Summary of Changes by WBS L2

Director's Cost & Schedule Review

14Jul09

WBS x.0 - ANU

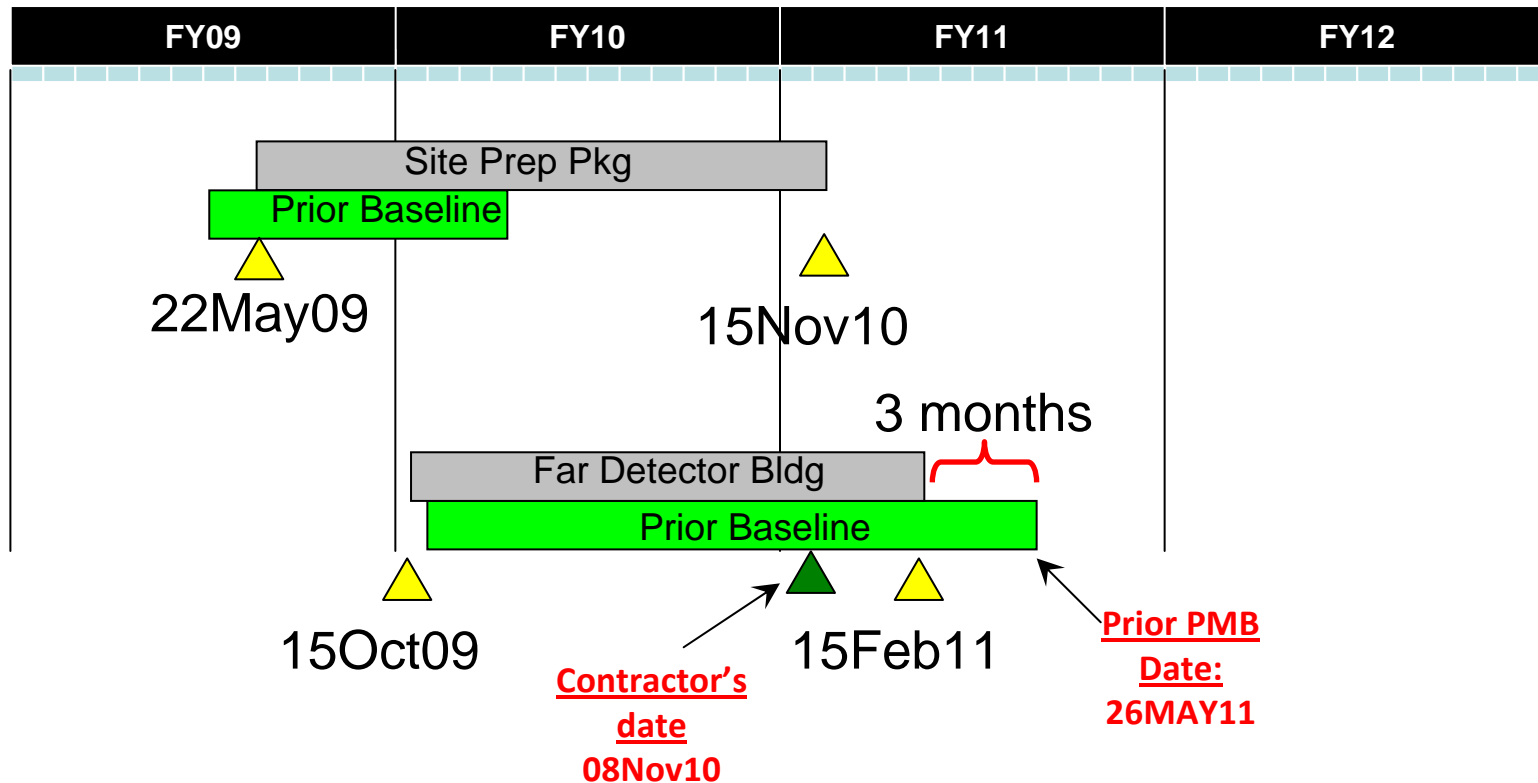
- EAC001 - reduced assigned labor hours by 30% for selected tasks in NUMI Upgrades R&D ~ \$100k reduction in EAC
- CR080 - delayed all un-started activities with current baseline dates in the “future” (as of 01Jun09) to start no earlier than 01Jan10. Updated ANU baseline for those tasks using their revised early dates
 - Delays Recycler Ring shutdown start date from 19Jul11 to 08Feb12 (~6.5 months)
 - Moved ~3.4M \$ out of Jun09 – Dec09 to after 01Jan10 in the budget
 - Net EAC/BAC increase due to delay (~393k)

Updates to Resource-Loaded Schedule WBS x.1 – Site & Building

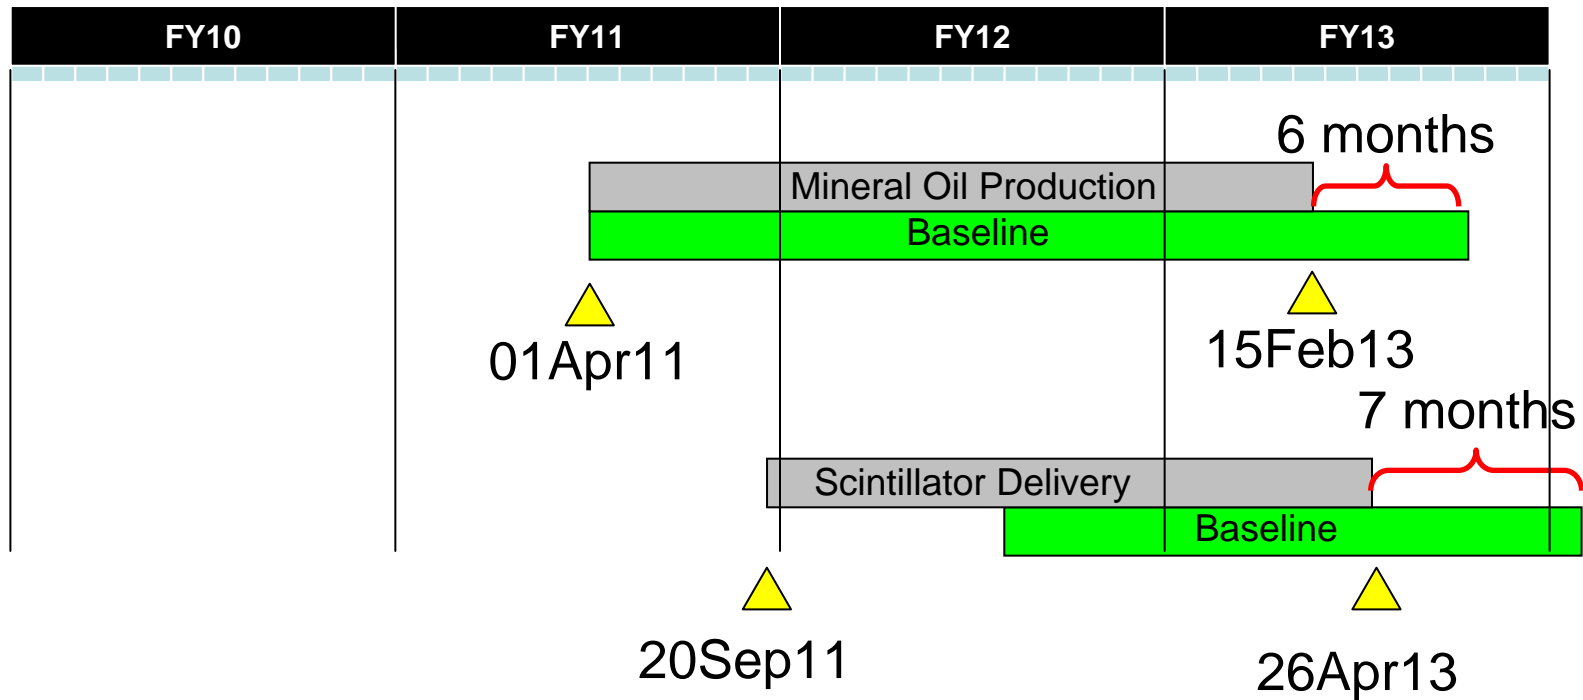
- CR073 – baseline change to incorporate contractor's planned schedule and budgets + additional 3 months added in Open Plan before updating the baseline;

BAC before: \$46,239M, BAC after: \$30,456M; decrease of 15.8M\$; also included is contingency reduction (22% → 8%);

WBS x.2 – Liquid Scintillator

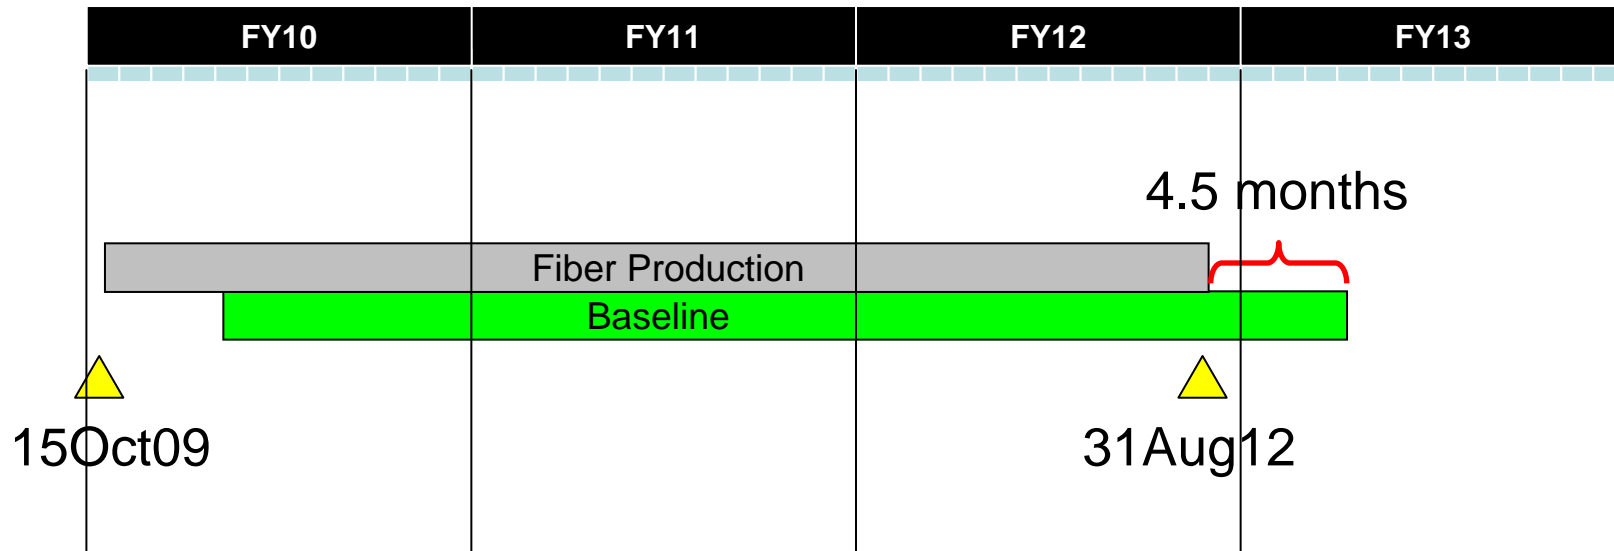
- EAC007 – increased base cost (\$3.36 → \$3.73 per gal., FY07\$) + contingency (28% → 45%); for mineral oil; changed purchased quantities of oil and pseudocumene per FY to accommodate filling schedule; advanced elements of scintillator blending and shipping schedule by 7 months to accommodate advanced far detector filling schedule; net EAC increase ~ \$1070k

WBS x.3 – WLS Fiber

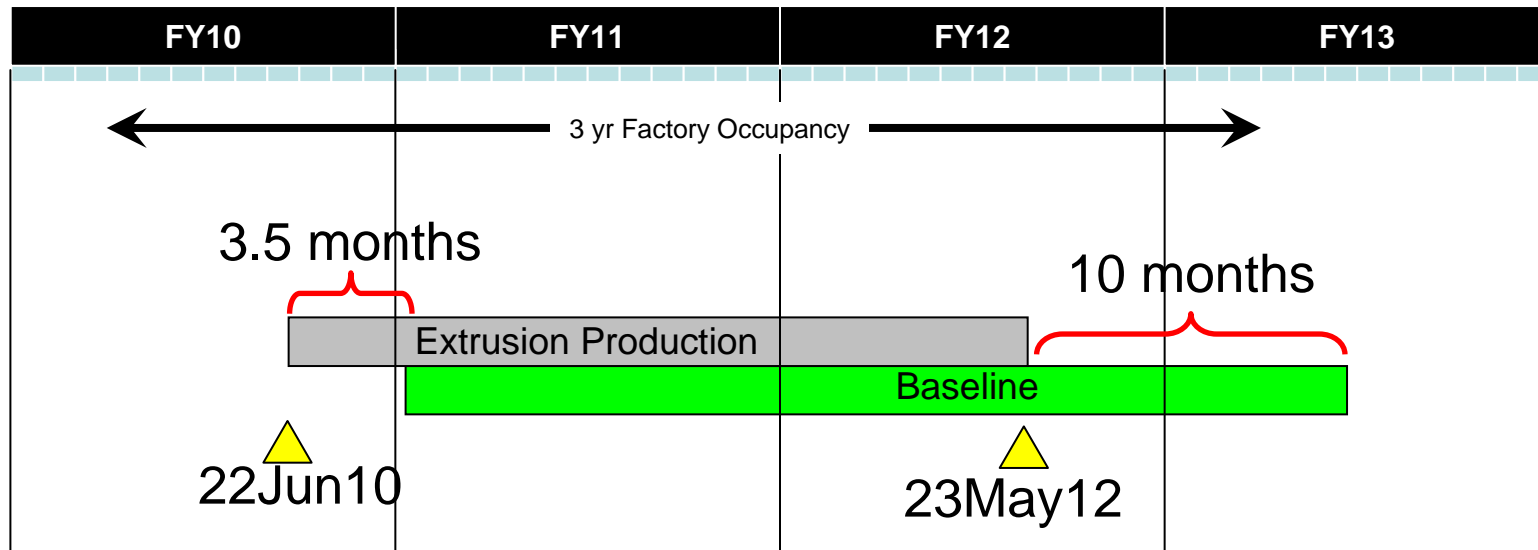
- EAC003 – increased base cost (\$0.765 per meter FY07\$, duty free) and decreased contingency (28% → 20%) for fiber production; advanced fiber delivery schedule ~4.5 months; EAC increase of \$949k

WBS x.4 – PVC Extrusions

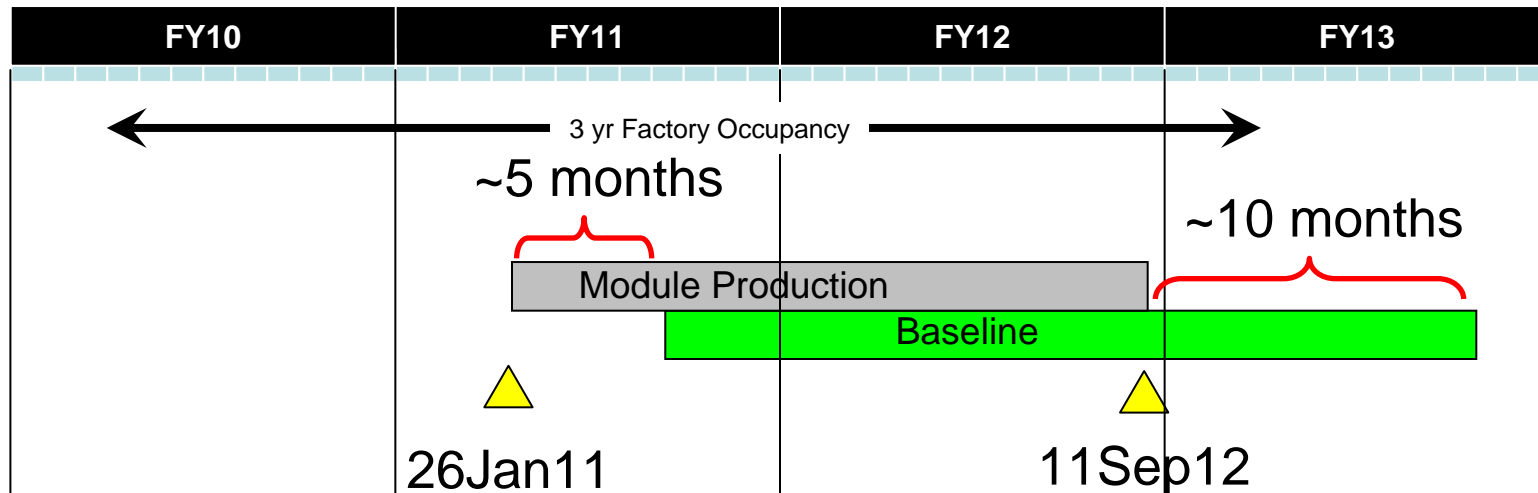
- EAC004 – advanced far detector extrusion production start by 3.5 months (to 22Jun10) and finish by ~10 months (to 23May12); removed slower ramp up; requires extrusion storage buffer size increase at module factory
- EAC010 – advanced near detector extrusion schedule for blocks 5 and 6 to align with IPND schedule (processed Jul09)
- \$408k combined reduction in EAC

WBS x.5 – PVC Modules

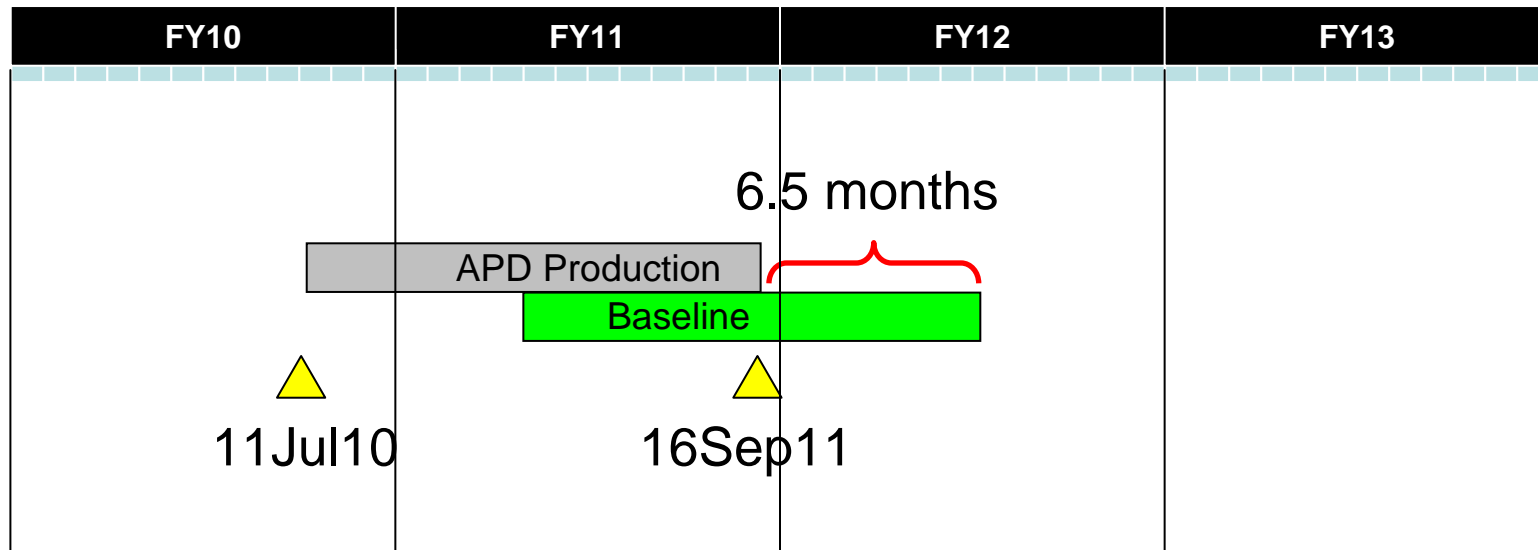
- EAC006 – advanced far detector module production start by 5 months and removed slower ramp-up to advance finish by ~10 months; increase in module (and extrusion) storage buffer size and changes in production schedule requires expansion of module factory; labor adjustments; net EAC increase of ~2.5M \$\$
 - Increase in factory leasing and operating costs (~1,380k increase)
 - Factory infrastructure adjustments (~ 15k decrease)
 - Tooling and fixturing adjustments (~403K increase)
 - Adjustments to block-by-block module assembly tasks (~1000k increase) (processed Jul09)

- EAC010 – advanced near detector module fabrication schedule for blocks 5 and 6 to align with IPND schedule ~ \$166k reduction in EAC (combination of schedule change and obsolete tasks)

WBS x.6, x.7 – Electronics/DAQ

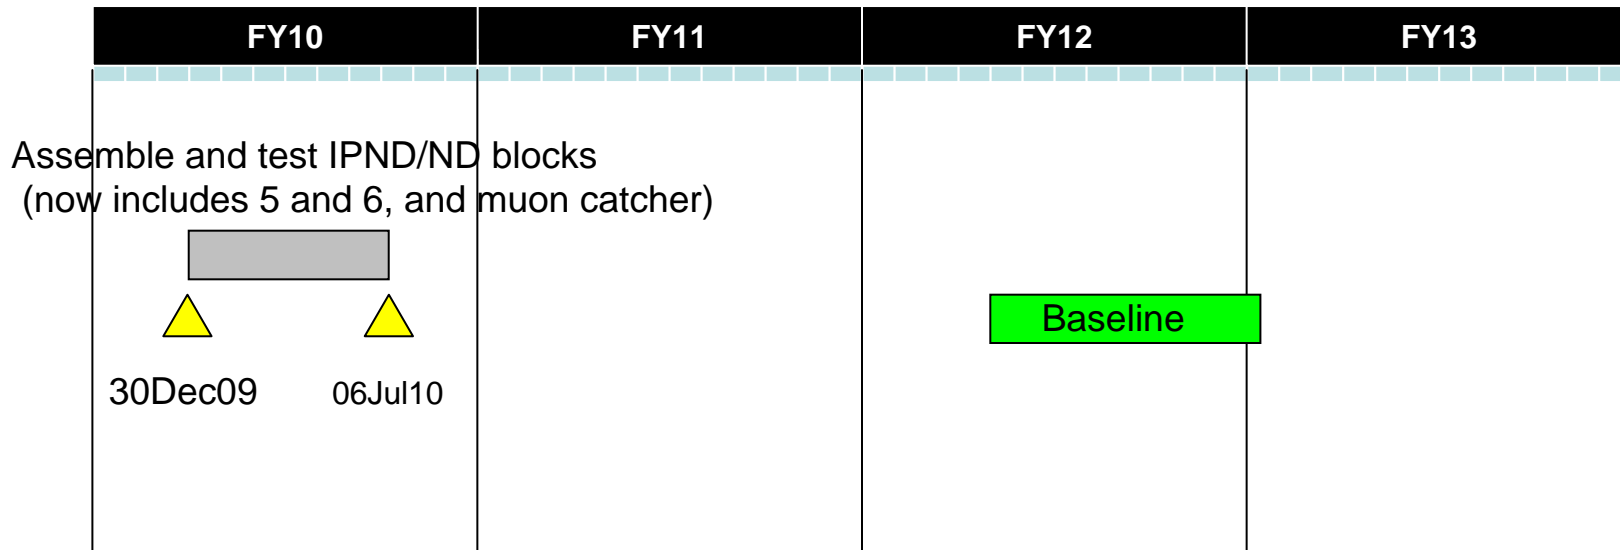
- EAC005 – advanced APD procurement schedule ~6.5 months (awaits receipt and evaluation of first 320 parts currently on order); will process as baseline change once final vendor schedule and firm unit price is known; EAC reduction of ~62k due to de-escalation
- No changes to DAQ other than that due to progress reporting each month.

Updates to Resource-Loaded Schedule WBS 2.8–IPND/Near Detector Assembly

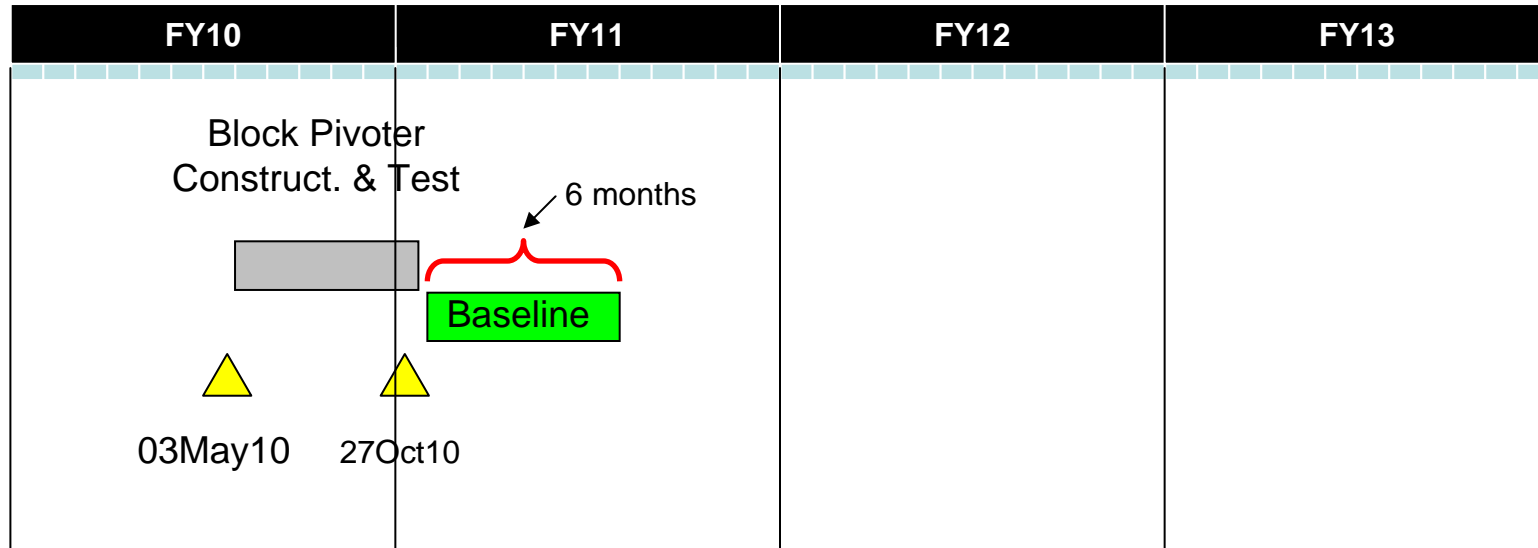
- EAC002 - reduced contingency on near detector cavern (100% → 50%)
- EAC010 - Advanced schedule for Near Detector blocks 5 and 6 and muon catcher (formerly coupled to time frame of block 10 far detector modules) to merge with IPND schedule ~\$166k reduction in EAC (combination of schedule change and obsolete tasks)
